Suffolk County Council response to Sizewell C Non-Material Change Application Reference EN010012

Appendix A Detailed comments on the 8 Changes of the NMC application

Figure 21 Extract from ROW Plan Sheet 22 of 28

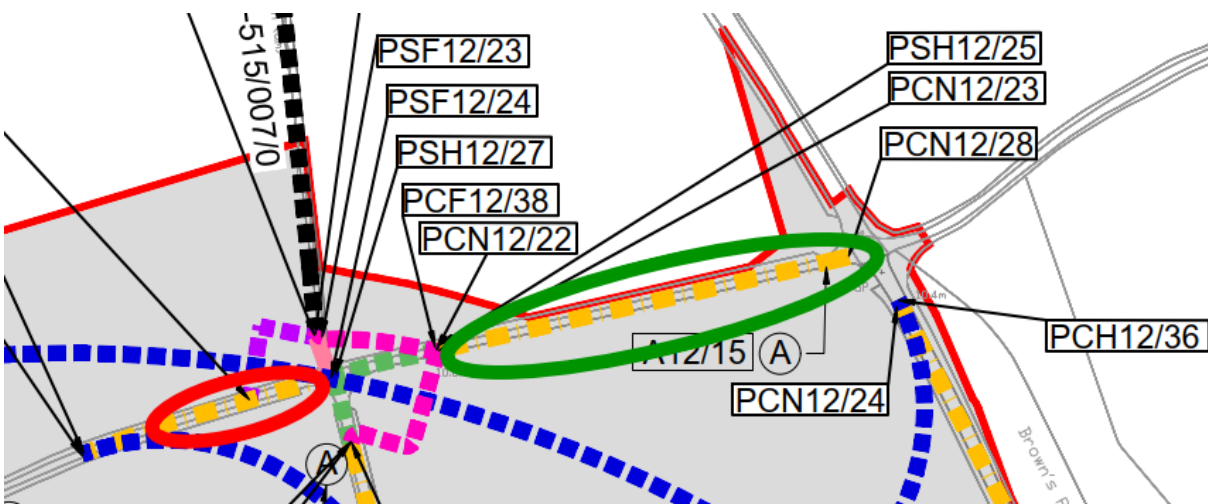
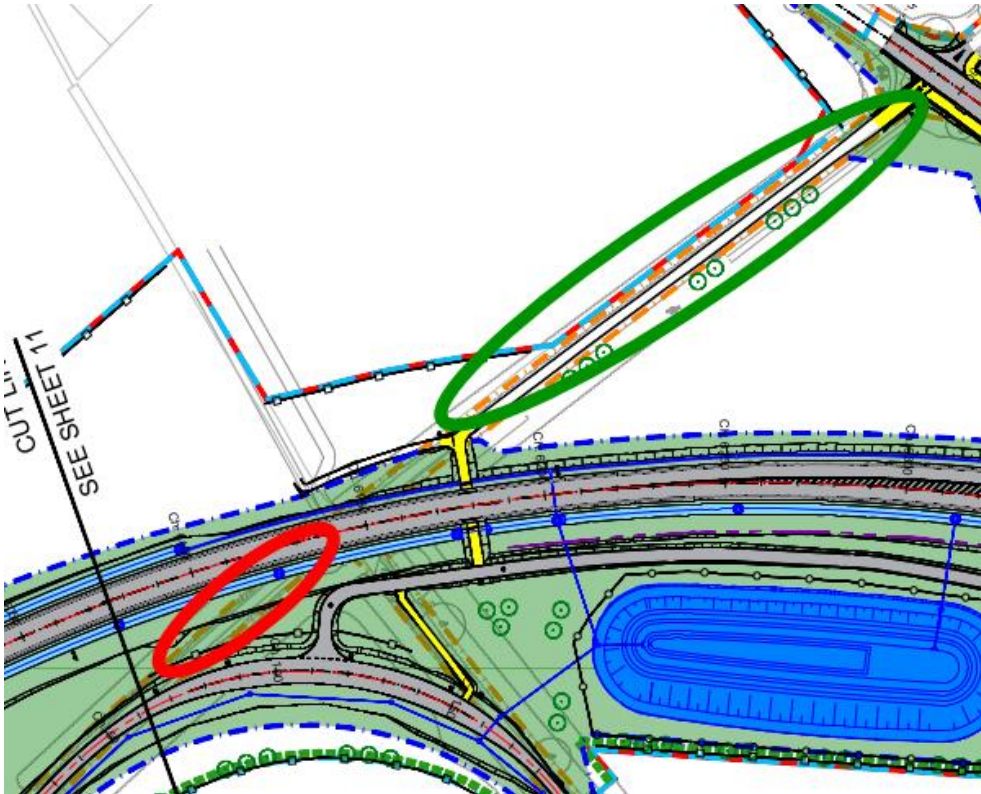
There are omissions in both the ROW Plan Sheet 22 and in Schedule 10, which results in part of Moat Road not being stopped up and an intended NMU route not legally created by the DCO, namely: -

- a) PCN12/28 is not listed in Schedule 10 Parts 1 or 3 and Schedule 11. What legal mechanism changes Moat Road to a highway for NMU from the B1122 at point PCN 12/28 to point PCN12/22? This is circled green in Figures 21 and 22.
- b) How is the section of Moat Road shown circled red in Figures 21 and 22 stopped up?
